## PLANNING COMMISSION MEETING

**RE: Comfort Care Assisted Living- Preliminary Site Plan Review – 2<sup>nd</sup> Review**

**RE:** Comfort Care  
Rezoning and Preliminary Site Plan – Review #2

DRAWING TITLE  
**SITE LANDSCAPE PLAN  
(NORTH DETAIL)**

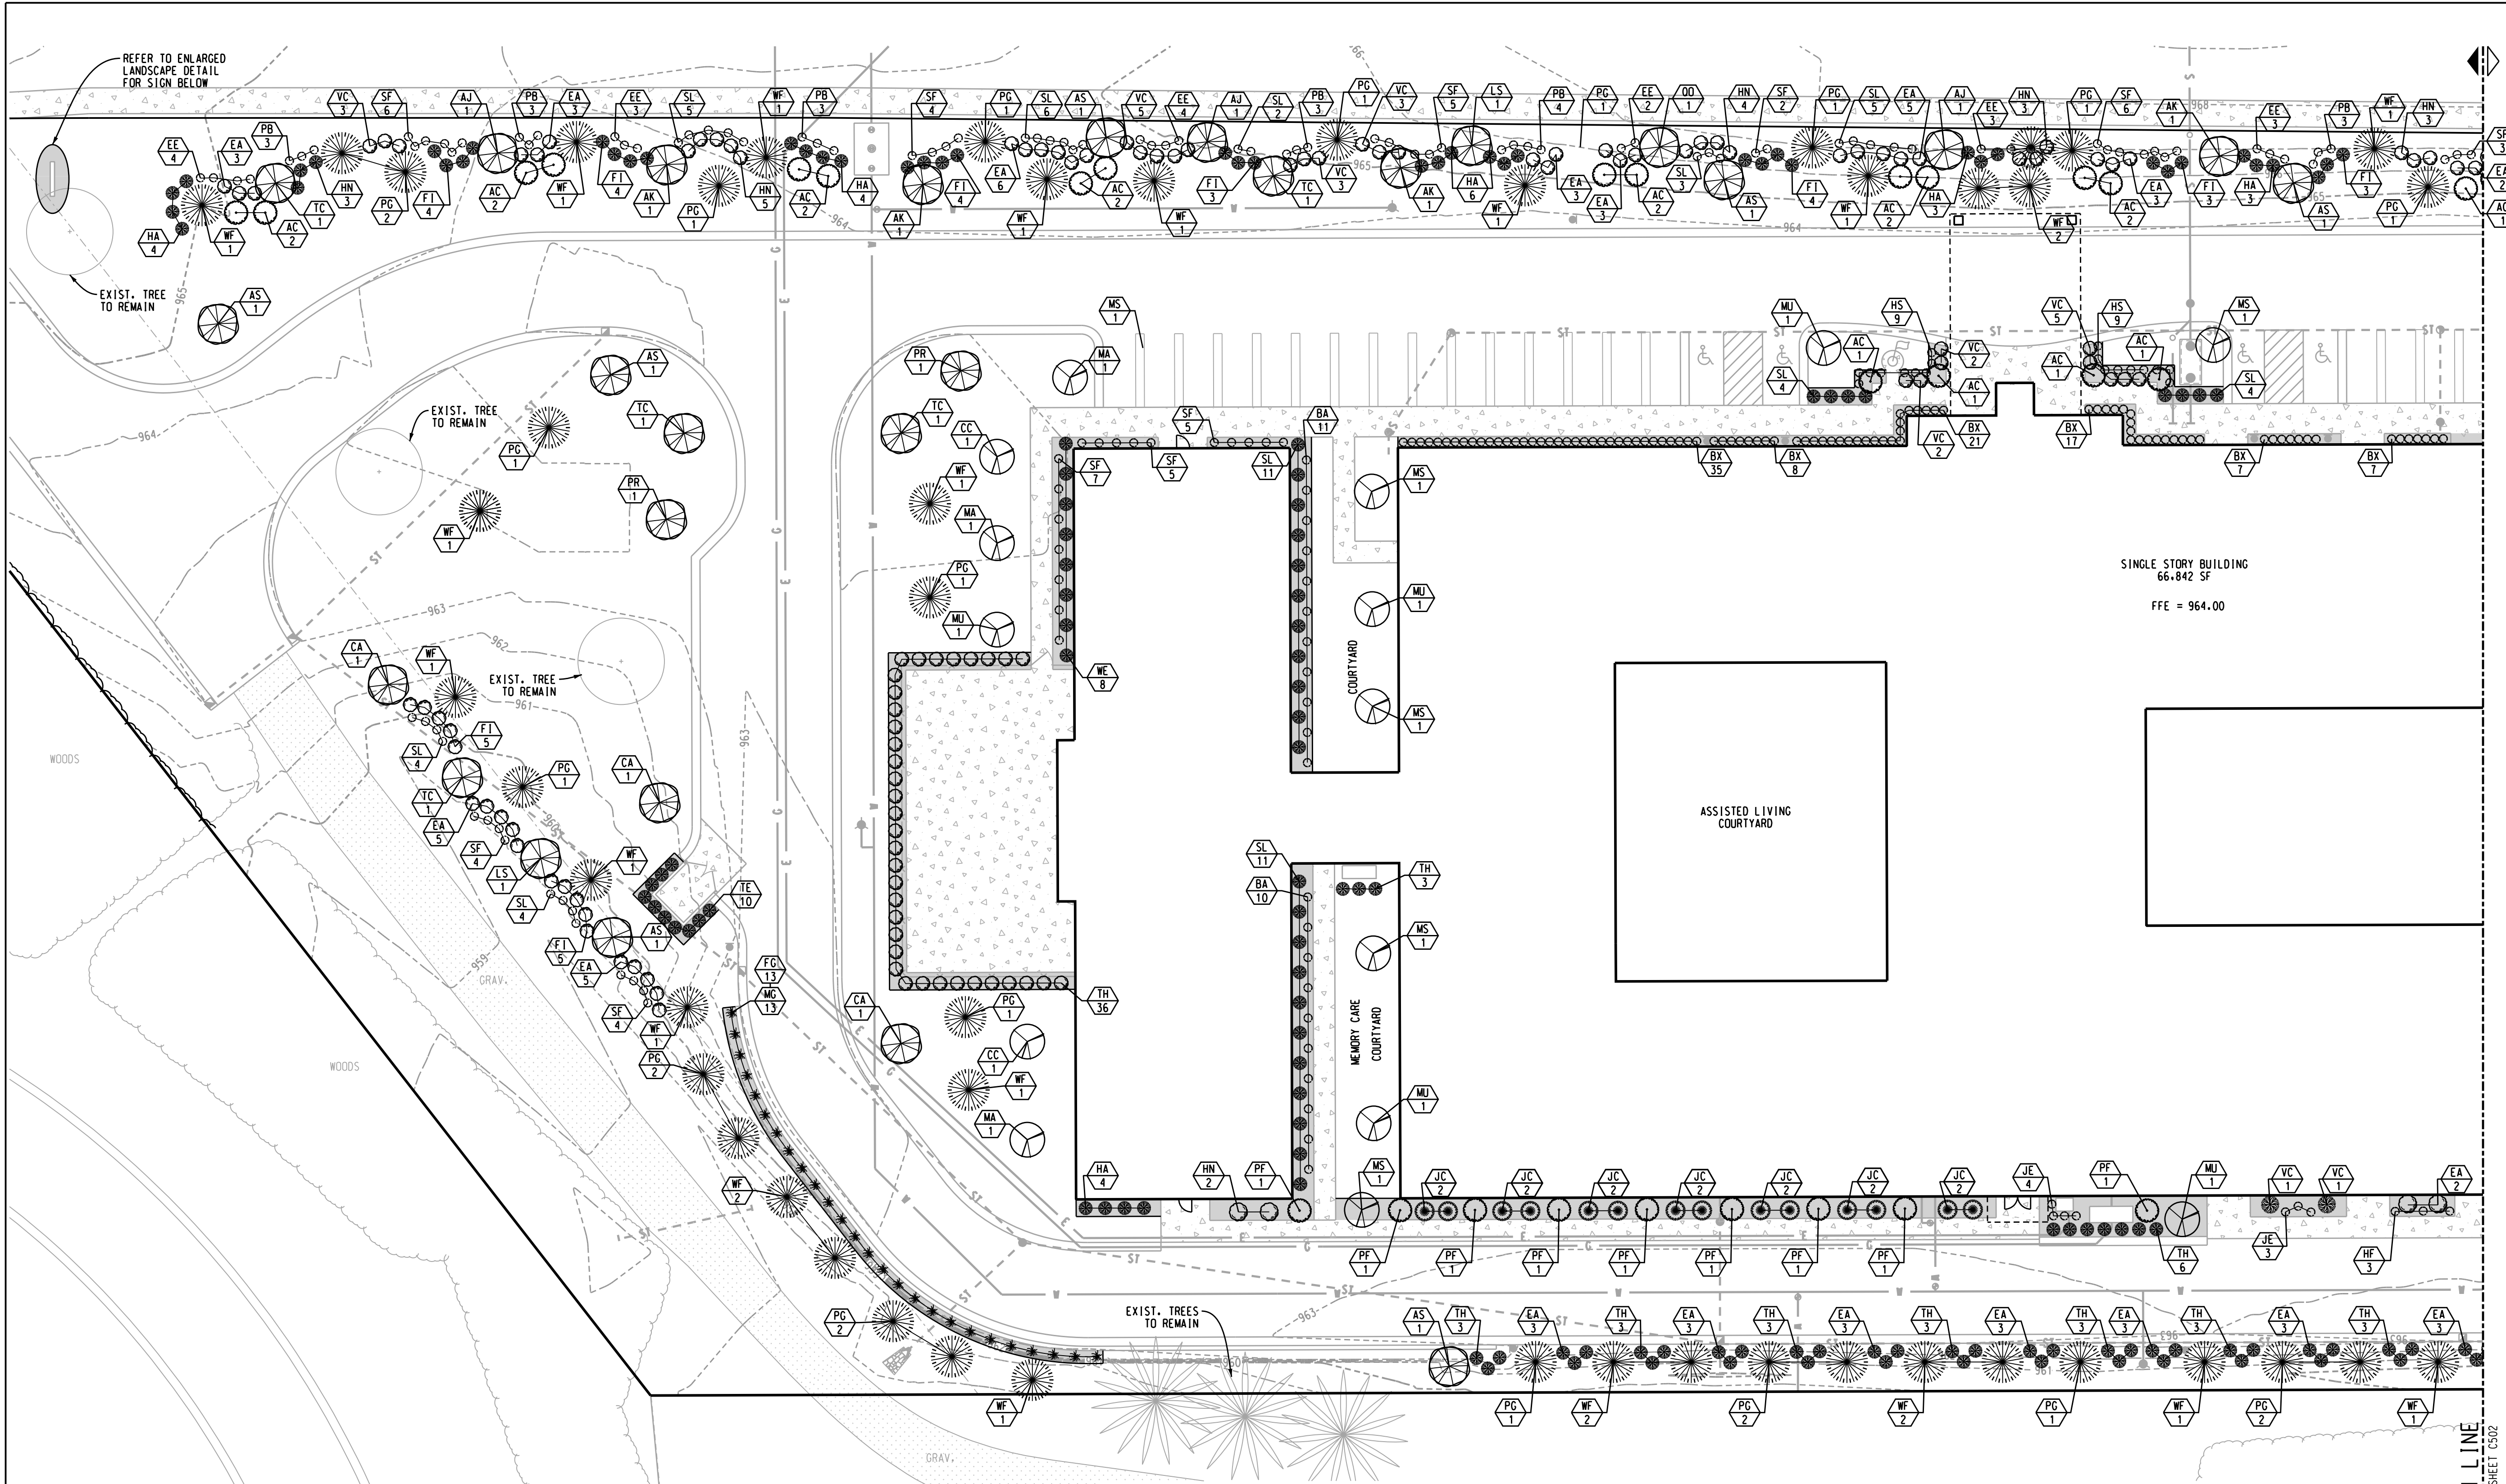
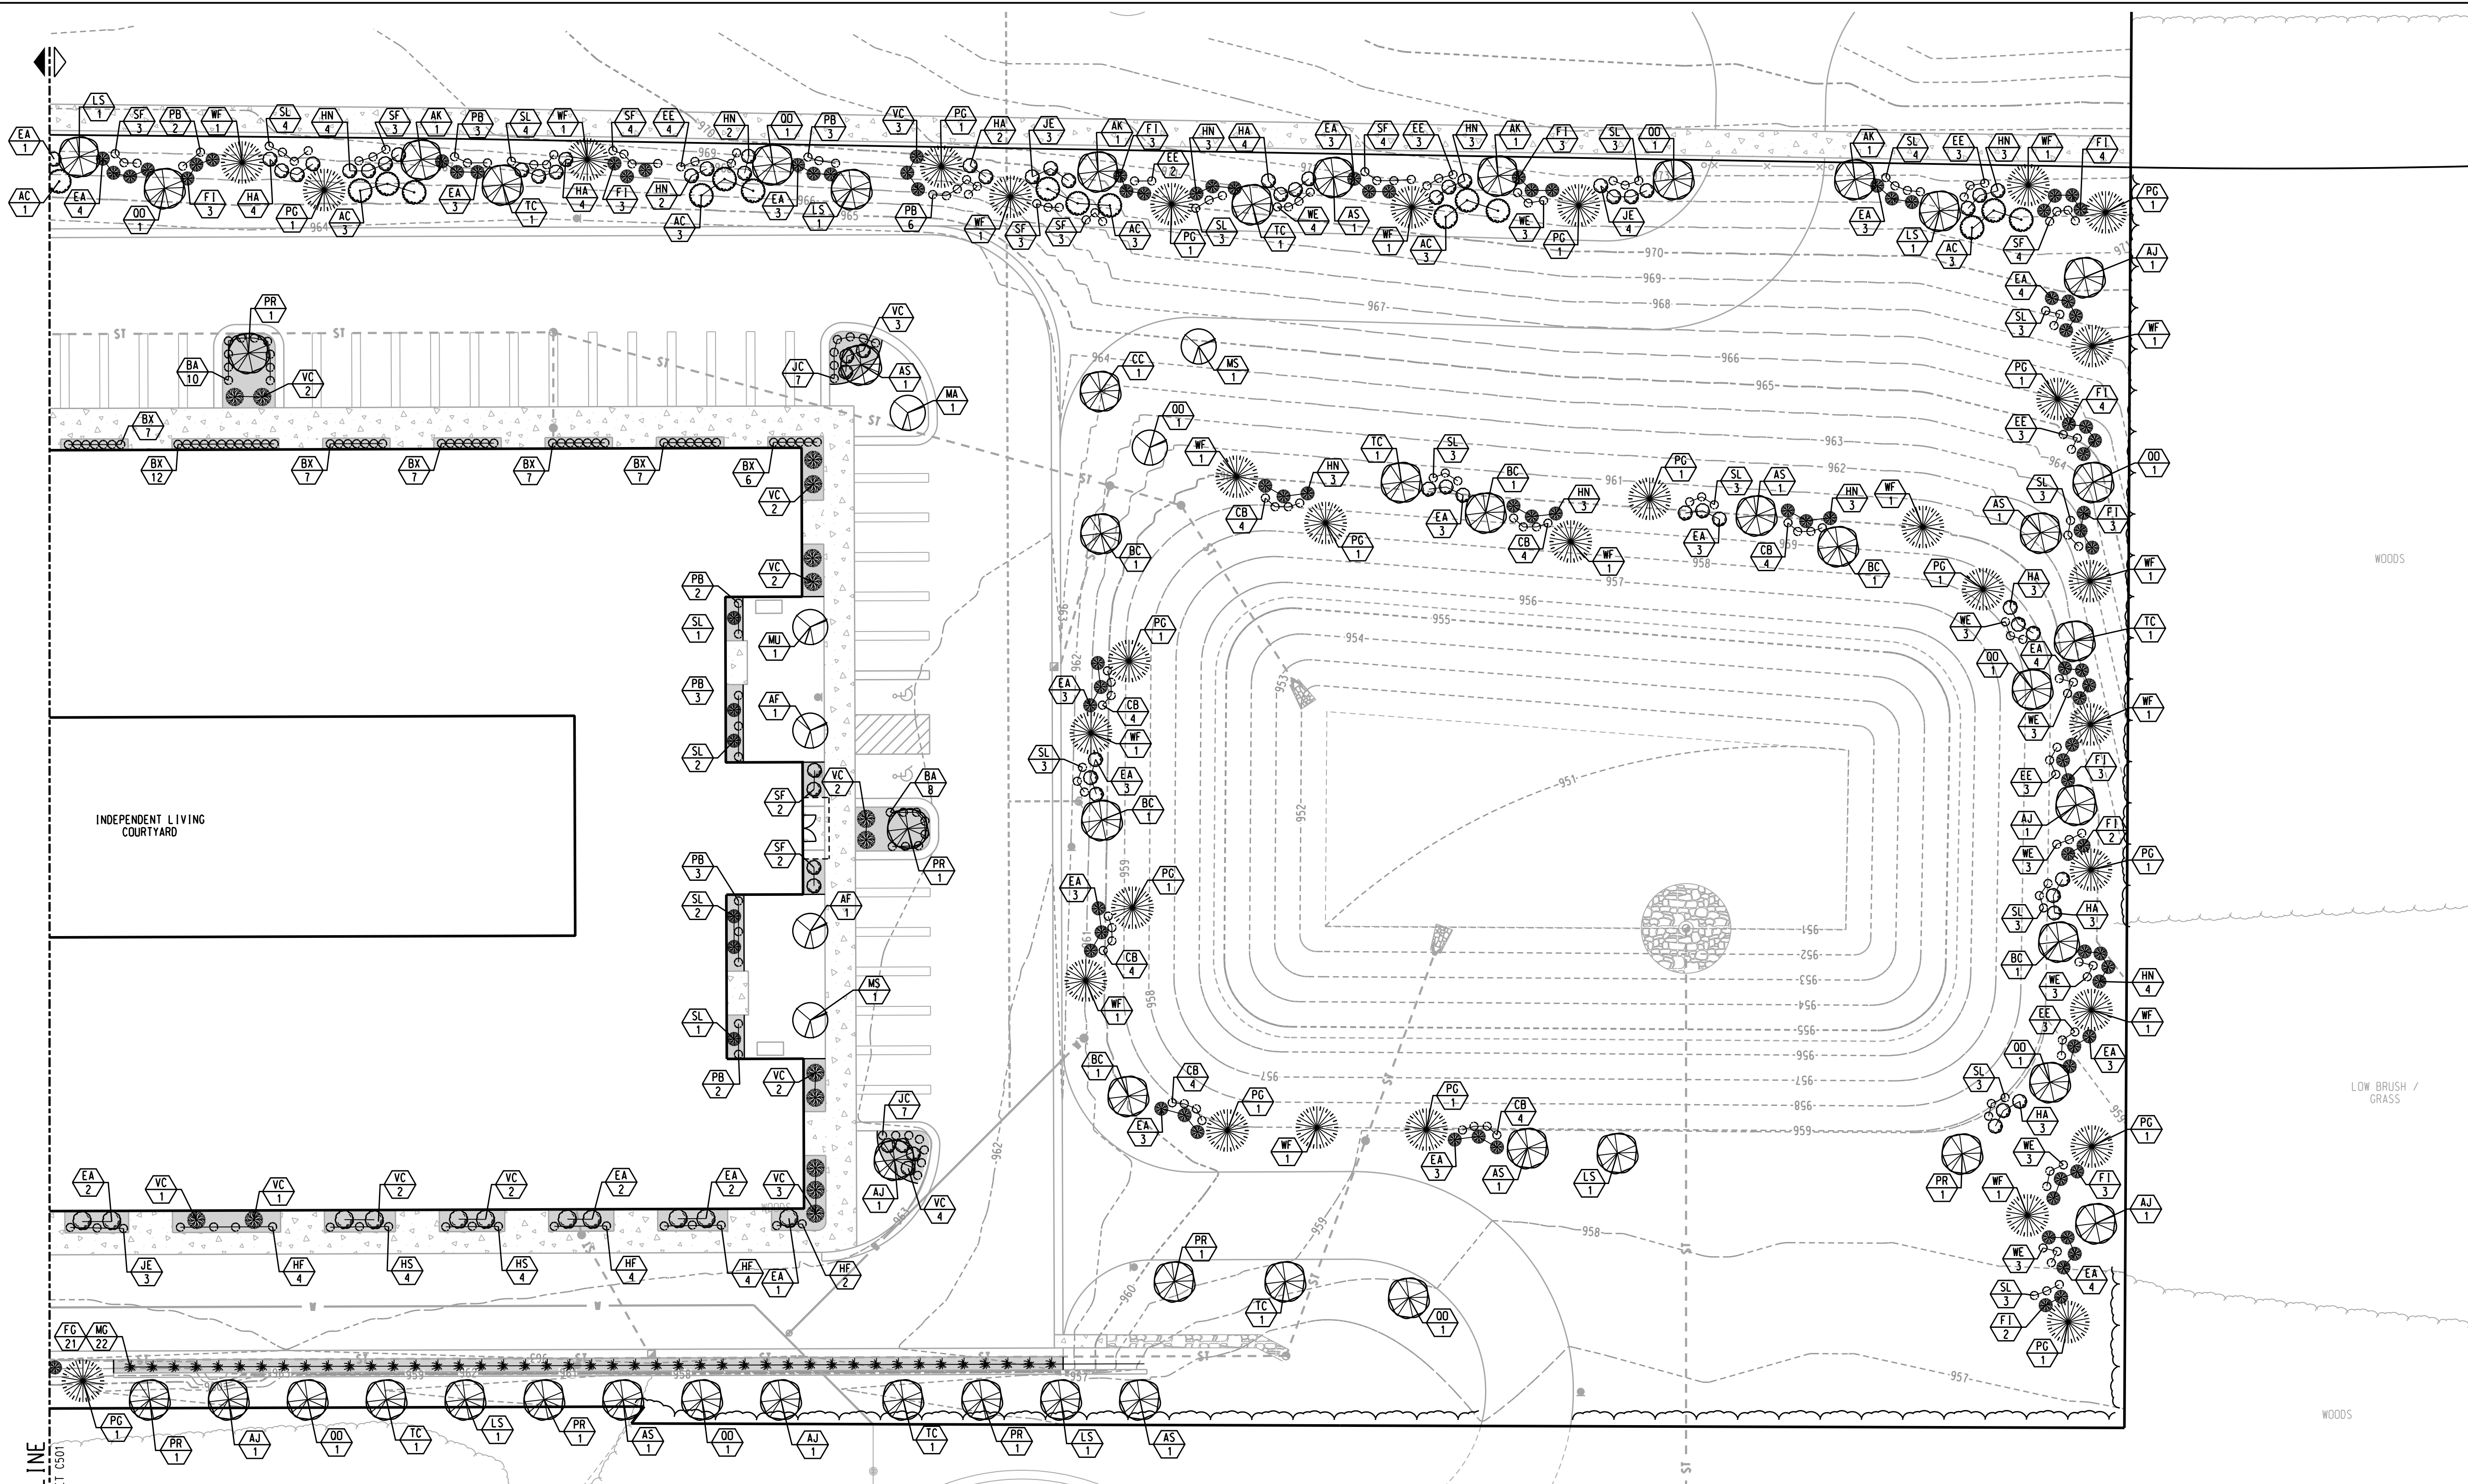
1. *Landscaping shall be revised such that proposed trees are located a minimum of 10' horizontal separation from all watermain, sanitary sewer, and storm sewer. Note that proposed trees appear too close to storm sewer along the western property line. **Comment outstanding.***

**OUTLET CONTROL STRUCTURE #2 (SOUTH POND)**  
NO SCALE

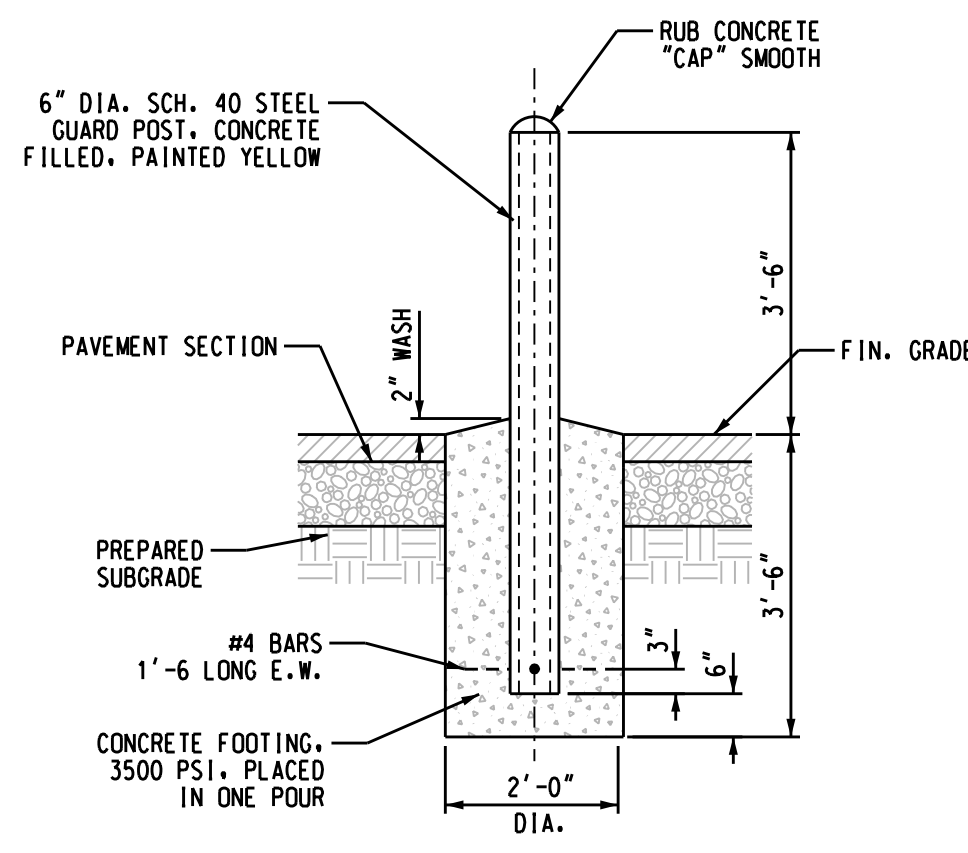
1. MH6 will need to be moved such that there is a minimum of 10' of horizontal separation between it and the proposed building. **Comment addressed.**
2. The design engineer will need to demonstrate that the proposed storm sewer material (ADS HD) will maintain its integrity when located under proposed pavement, otherwise use CLIV Reinforced Concrete pipe within pavement influence. **Comment outstanding.**
3. Sheet C300 – Site Grading Plan indicates a 15' wide storm sewer easement for West Valley; easement width is 12'. **Comment outstanding.**
4. Clarify on the Soil Erosion Plan as to why the OCS structure in the basin is to be temporary. **Comment outstanding.**
5. Clarify reference to South Pond on OCS#2 detail on Site Details sheet. **Comment outstanding.**
